Sydney Olympic Park New High School

Architectural Response to SDRP Report

Previous and amended layout

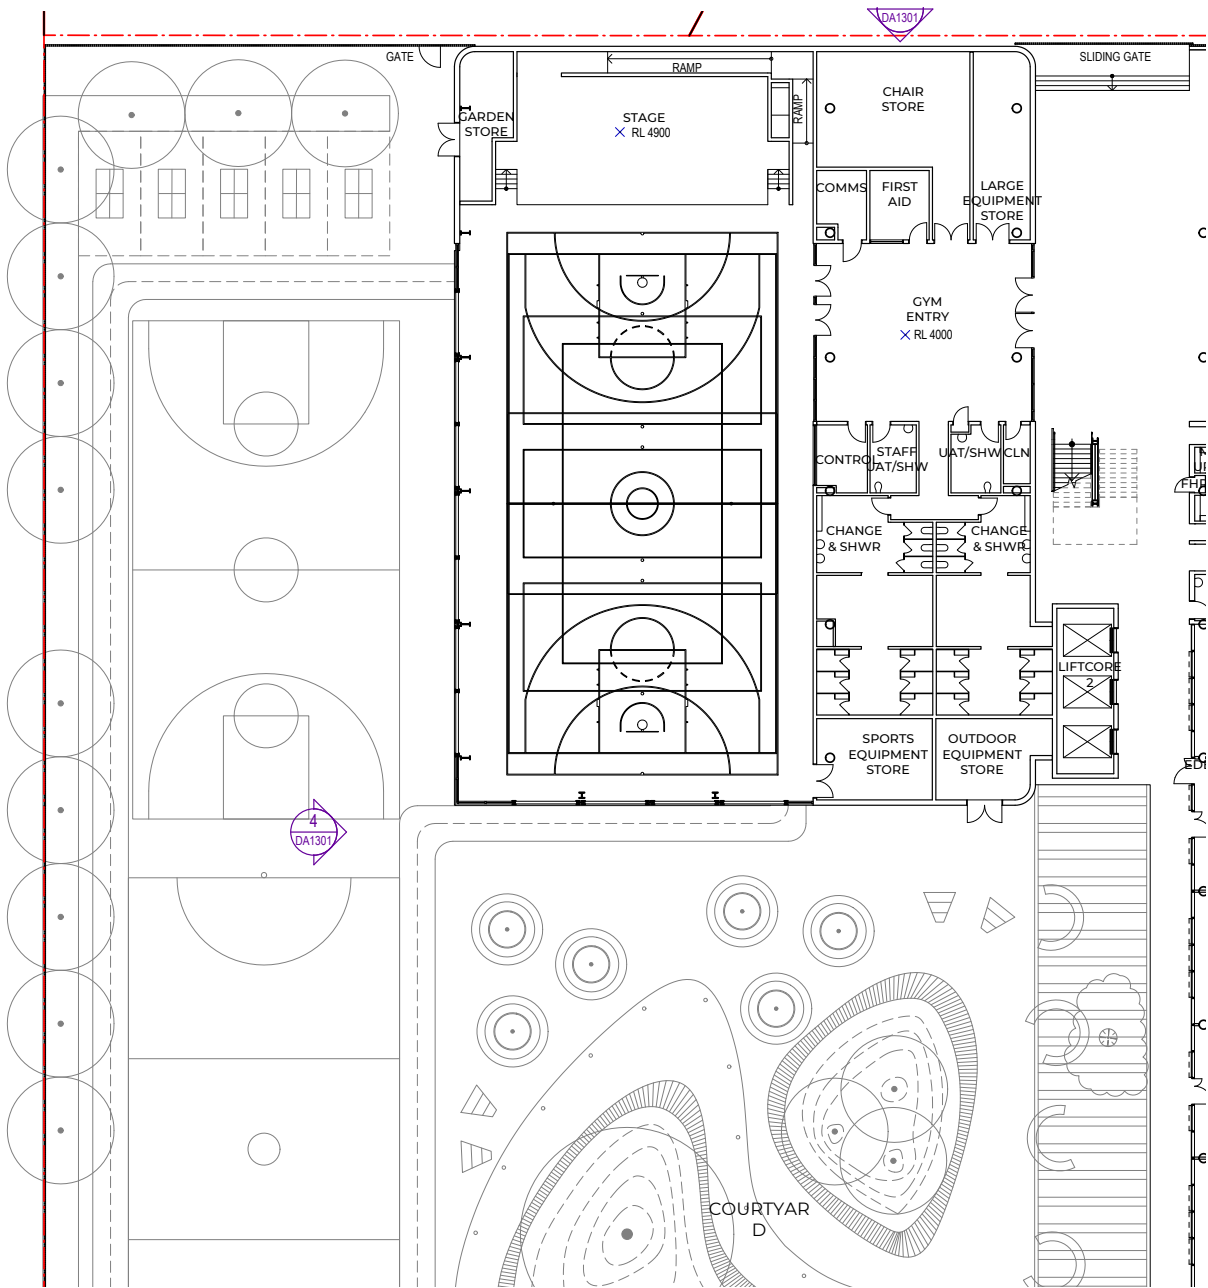
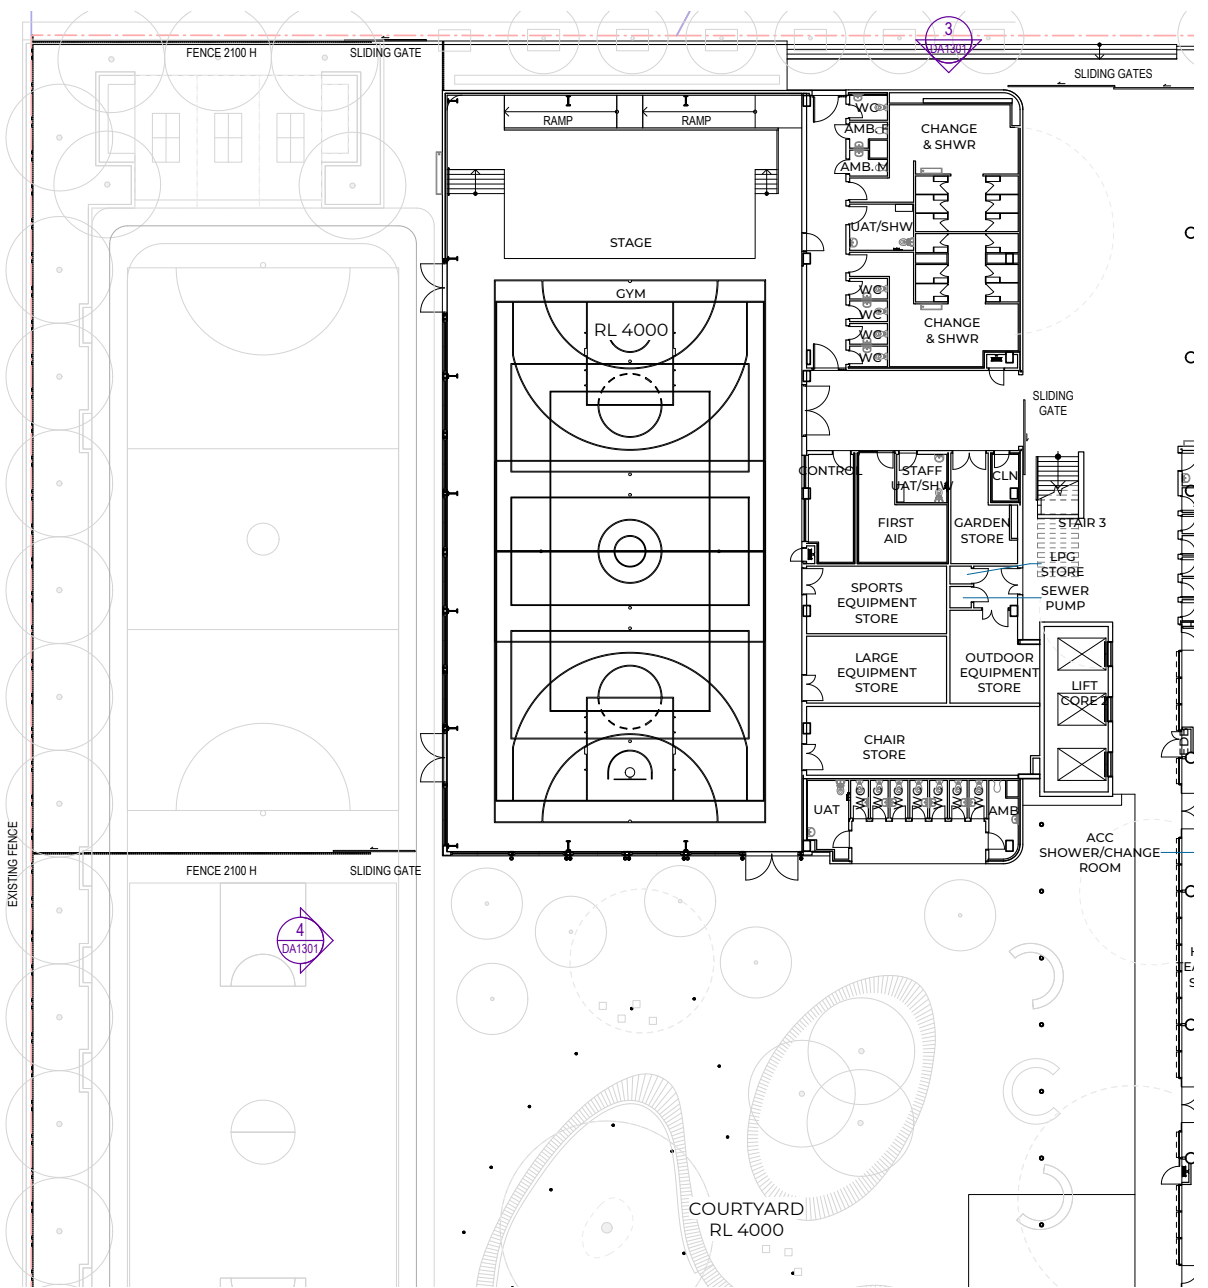
Comment: Access and connectivity – Illustrate the physical and visual connections through the school site for both the school community and the external community.

Architectural and landscape elements along school's perimeter have been shifted to enhance physical and visual connections between the school and its urban context, and to provide optimal flexibility and usefulness in operation.

As noted in the response to item E9, the width of the undercroft opening onto the school courtyard has been more than doubled, significantly increasing views through the space.

The bicycle parking facility at the south-western corner of the site has been physically lowered, halving the height of the retaining wall required on the footpath edge and promoting views to the playground beyond. Physical access to the bicycle store has been widened to better serve students entering the school in this location, and the mitigate the risk of collisions between cyclists and pedestrians.

The gym and northernmost sports court have been re-configured to facilitate controlled access to these amenities outside of school hours. A fence and sliding gate have been added between the western boundary and gym building. During school hours, the sliding gate is held in open position to maintain a unified playground for students. After hours, the sliding gate is closed, and a second gate on the boundary with the sports field can be opened to give access to the sports court. In this mode, the gym can remain secure, or can be made accessible as well.

The change rooms and toilets attached to the gym have been rearranged to allow similar flexibility

of use. These facilities are placed along a corridor with lockable doors at each end, one of which opens directly onto the sports field. On weekends and after hours, the field-side door can be opened to permit access to the change rooms and toilets, while the other door remains locked to secure the rest of the school grounds.

Articulation of external facades

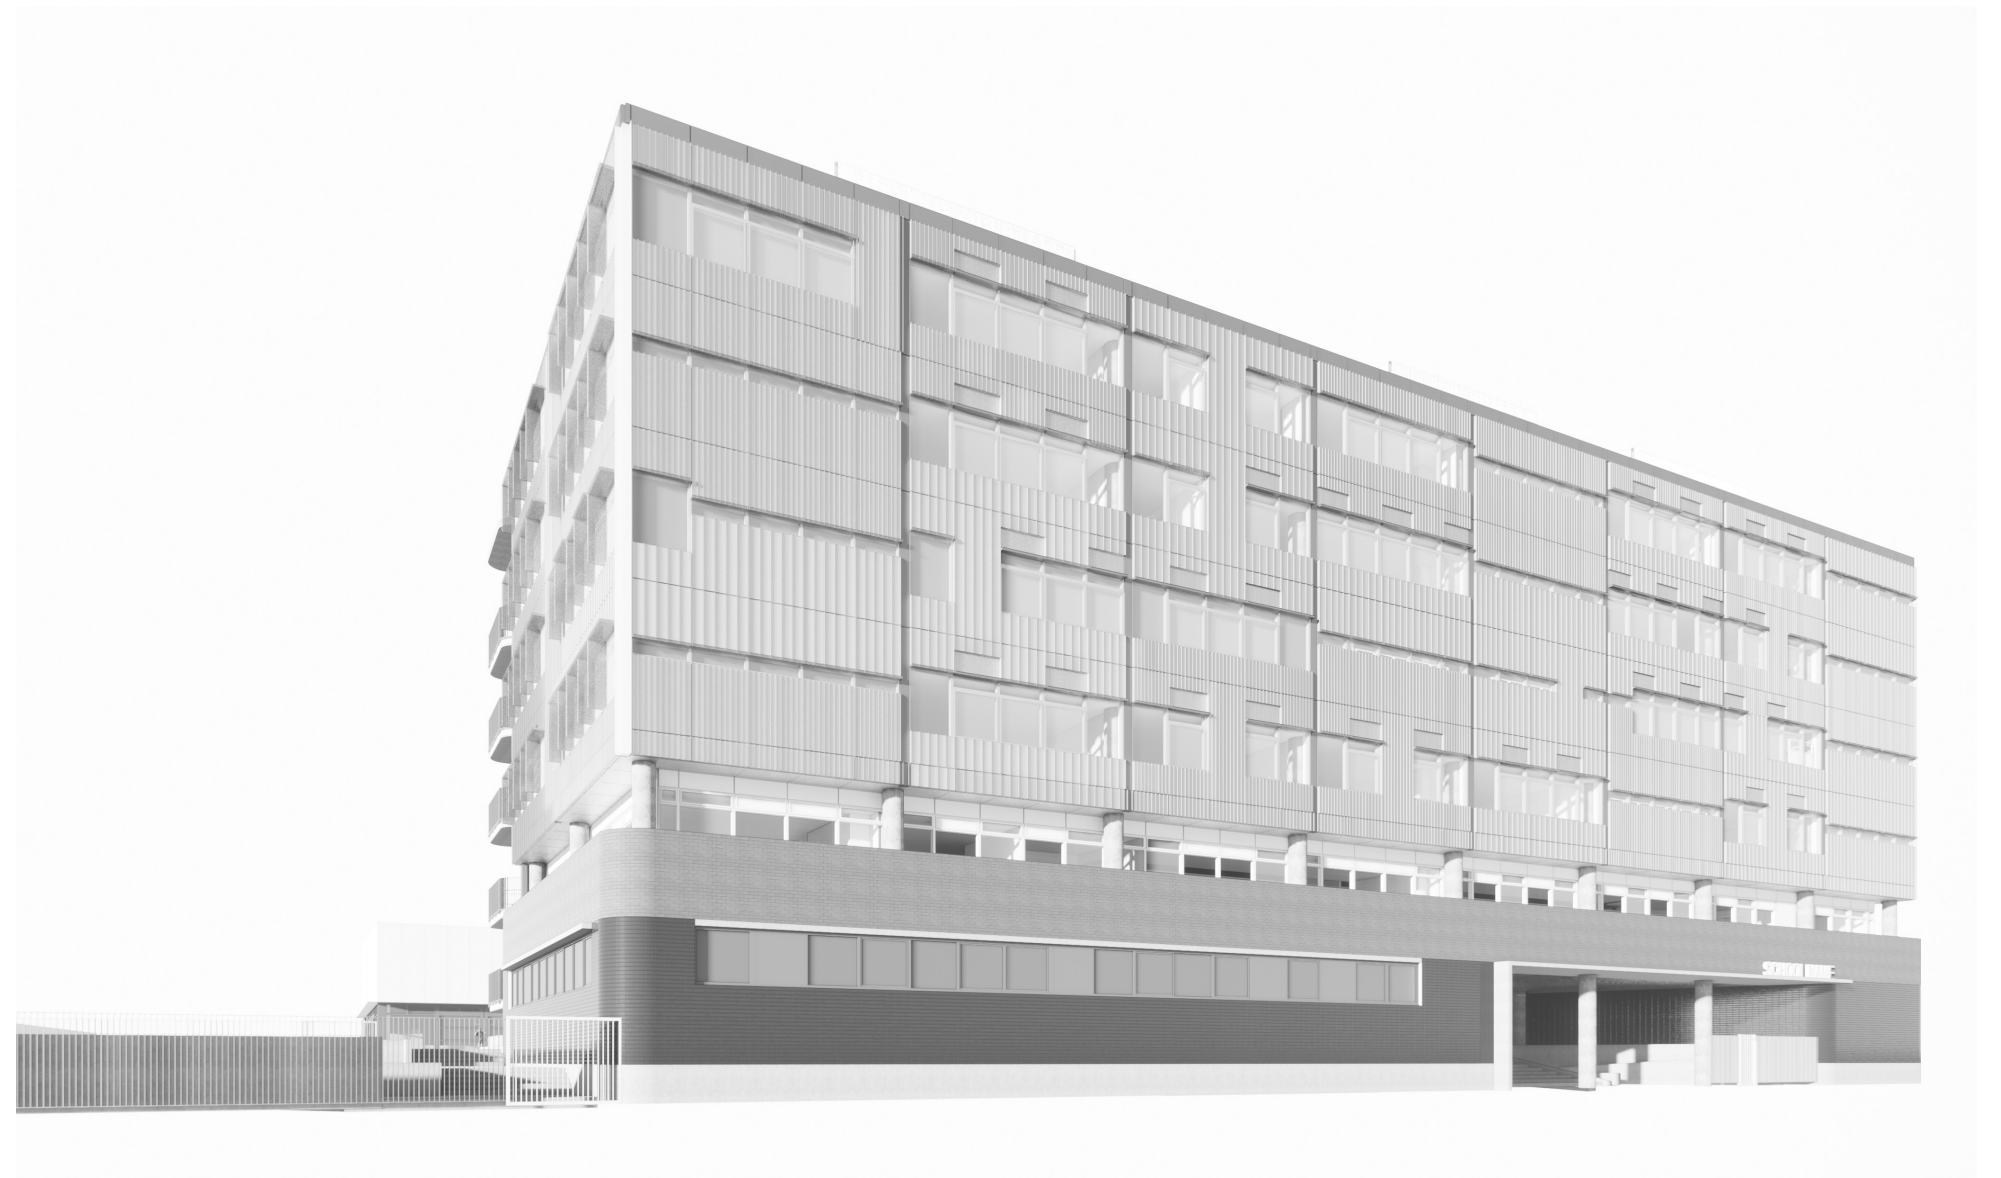
Comment: Façade articulation – The building presents a rich and colourful façade to the interior while presenting an austere façade to the surrounding context. Articulate the external façades to mitigate this condition, providing glimpses into the school grounds from the public domain and further reinforcing the civic and community presence of the school.

Since the early stages of this project, a central aspect of the design concept has been for external façades to pragmatically express the needs of internal spaces. Each space within the building has varying requirements for daylight and ventilation, based on use and orientation. Accordingly, the façade module attached to each classroom, laboratory or storeroom takes on a differing expression, modulated in terms of window size, sun shading device, louvred vent panels, and so on. The result mix of façade modules combine to create intriguing and serendipitous compositions, resisting a sense of uniformity or rigidity settling into the southern and eastern elevations.

The façade, with its mix of metal and glass, its relief, diversity and texture, enters into a dialogue with the “big sky” – it shimmers, distorts and reflects the ever-changing Wentworth Point sky. Taking into consideration the concern expressed by the SDRP regarding the perceived austerity of the street-facing facades, the design team stands behind the original design intent. The anodised aluminium cannot be seen as a stand-alone material – it is inseparable from the sky that defines it from all angles. Texturally, the aluminium panels are varied, with different aluminium profiles and integrated perforated panels used for natural ventilation. Horizontal and vertical shading fins, along with operable awning windows, add depth and add a play of shadow into the façade’s appearance. In addition, the anodised aluminium constitutes a highly robust material, well suited to the harsh estuarine environment in this location.

Facade detailing

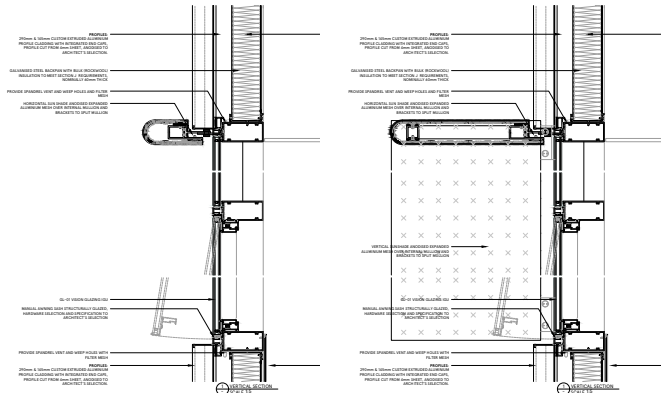
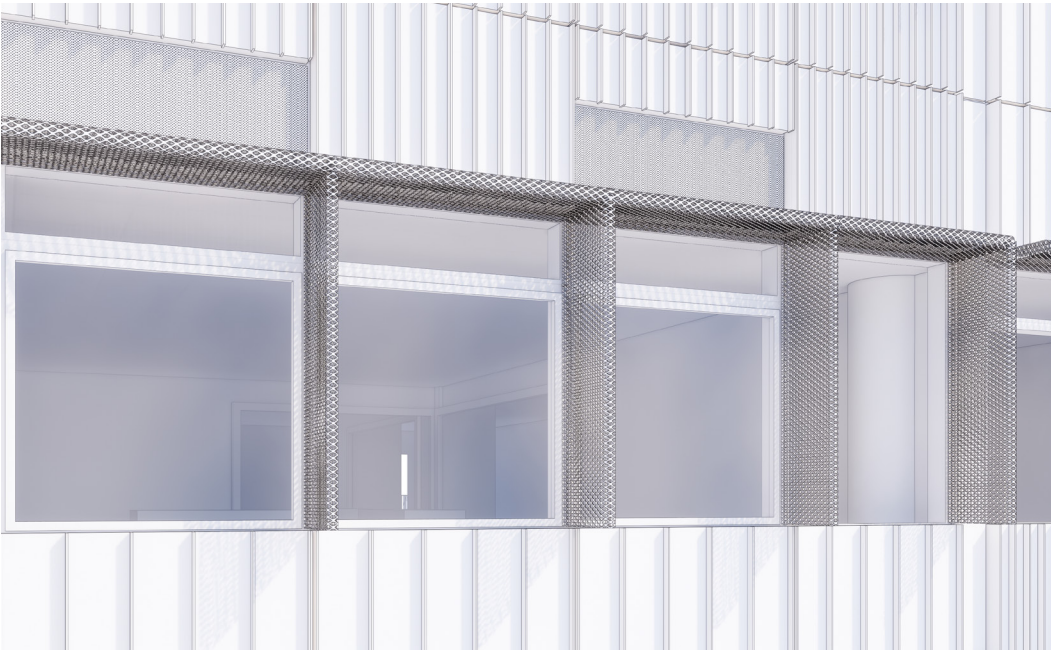
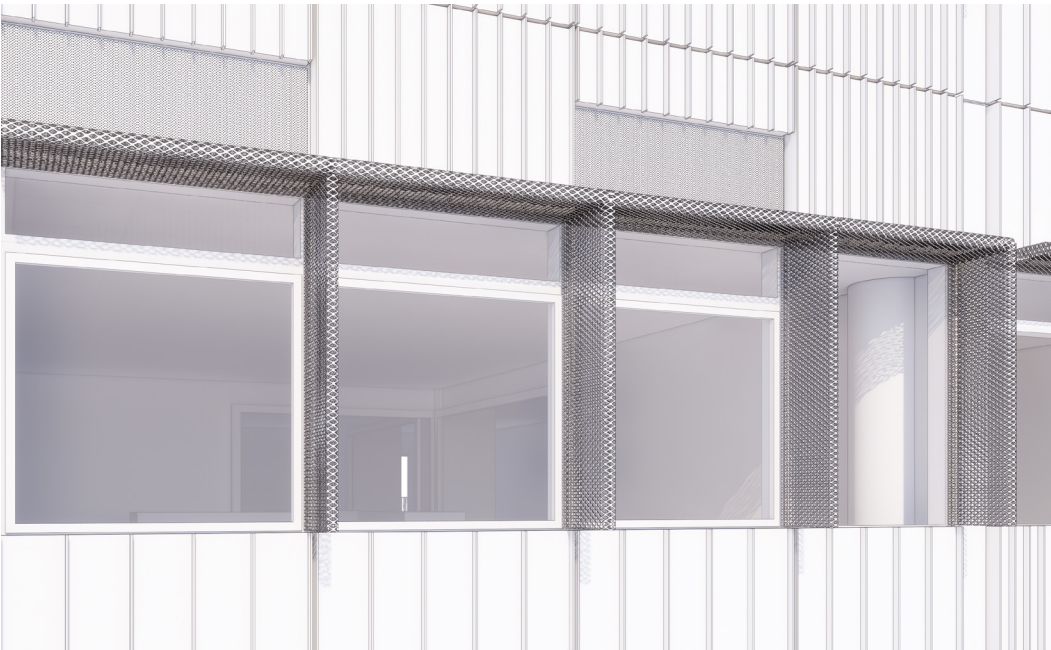
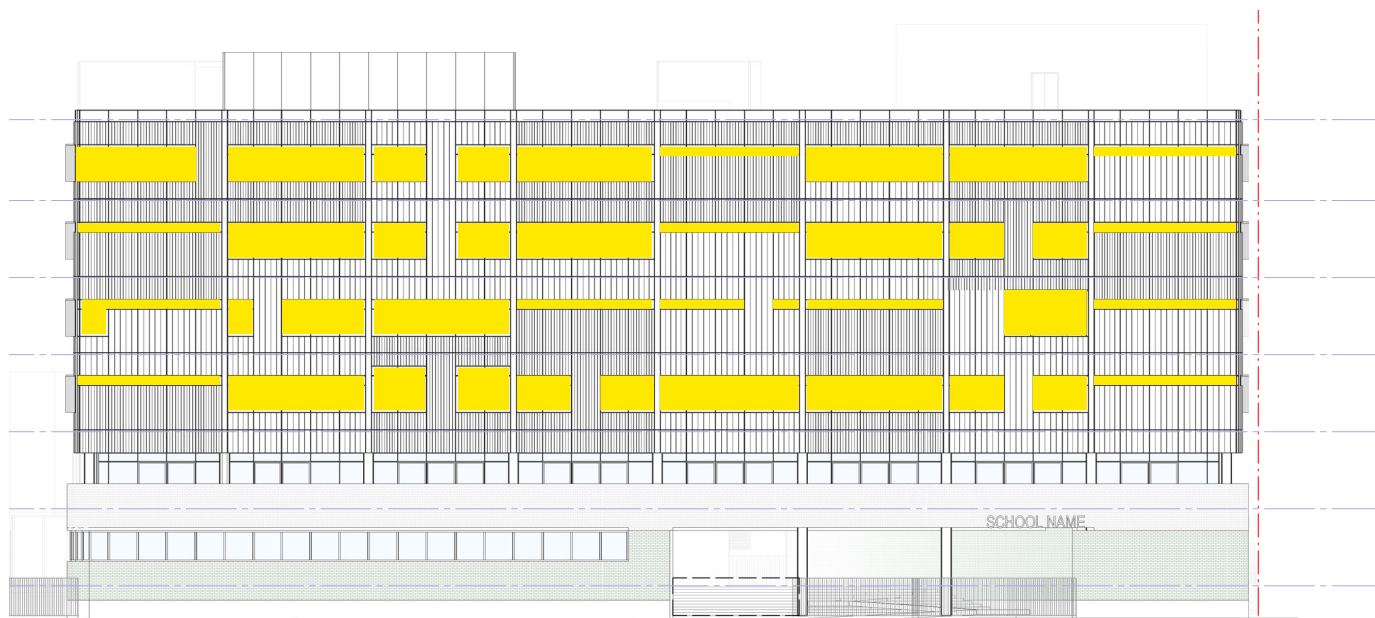
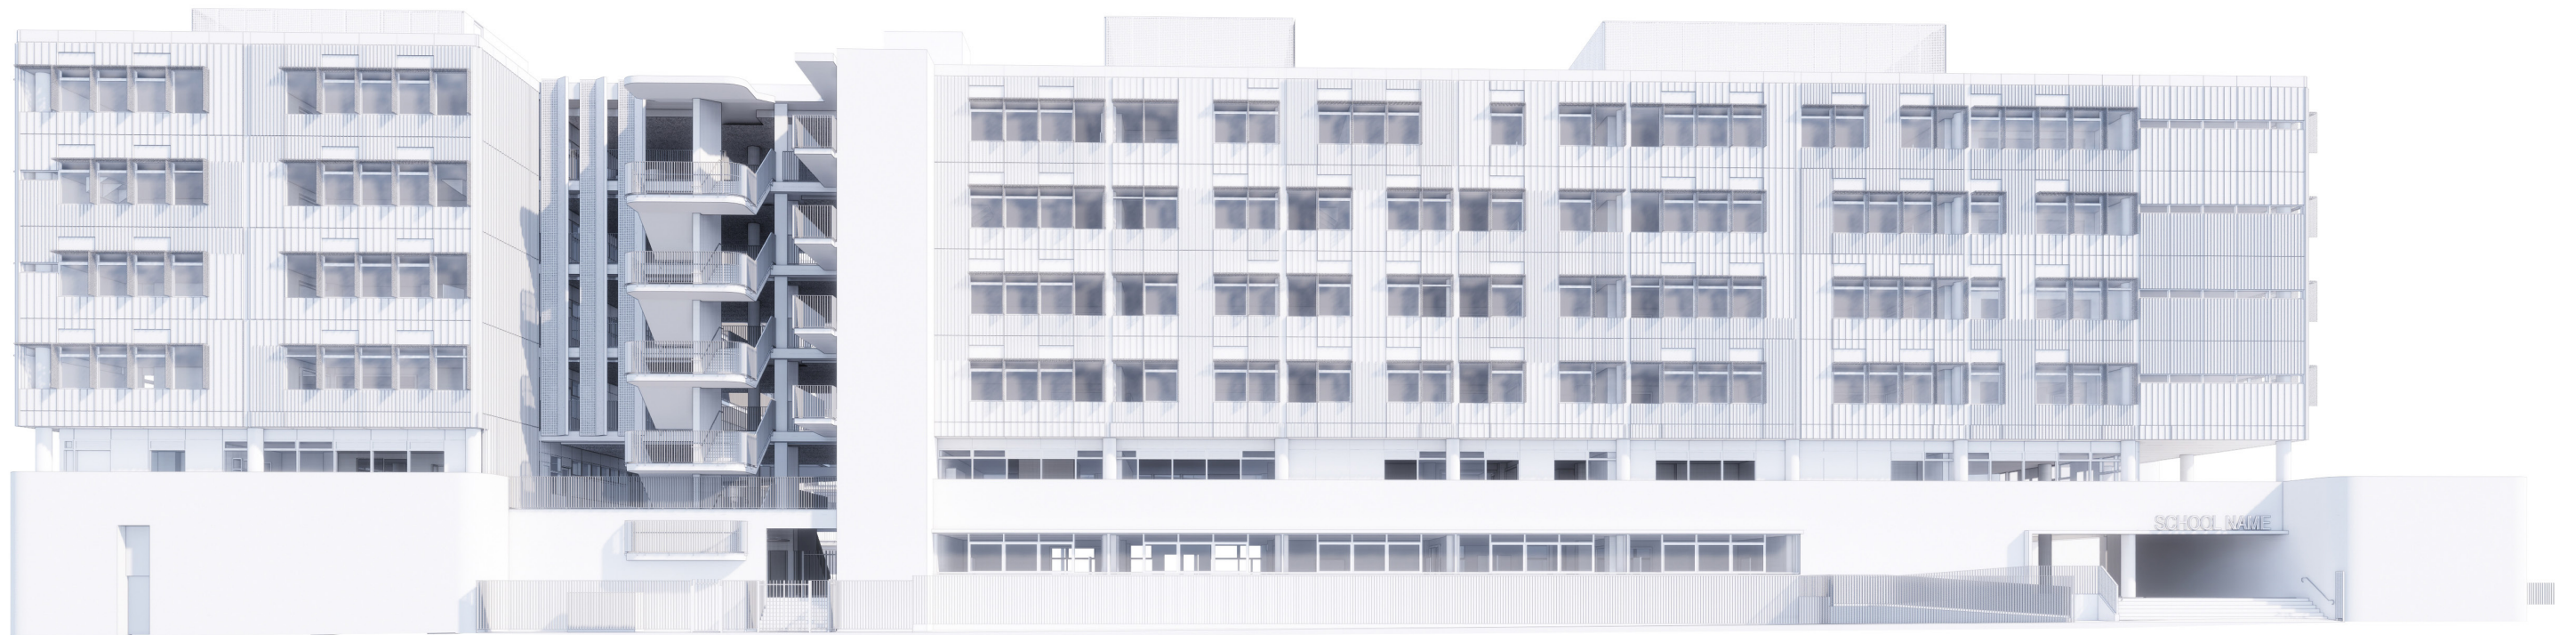
Authority: State Design Review Panel
Item: E13
Comment: Façade detailing – Illustrate development of the façade in relation to patterning and articulation.

The design of external (i.e. street-facing) facades has been developed to enhance the level of articulation, patterning and visual interest. Previously, the head of all windows on external facades were set at a consistent datum. By lowering all highlight windows by approximately 400mm, the head datum has been broken; windows appear to step up and down serendipitously, adding complexity and greater visual interest to the composition of the façade.

As part of the project’s mixed-mode ventilation strategy, intake and relief louvres are required to bring outside air into teaching spaces where operable windows are not suitable. These louvres, which are distributed along external and courtyard facades, contribute to a more articulated and finely patterned façade.

In addition, shading elements have been incorporated into curtain wall glazing with each window having a horizontal sunshade profile or a horizontal and vertical sunshade projection. The remaining areas of cladding are opaque extruded aluminium cladding which incorporate extruded vertical ribs which provide self shading to the facade.
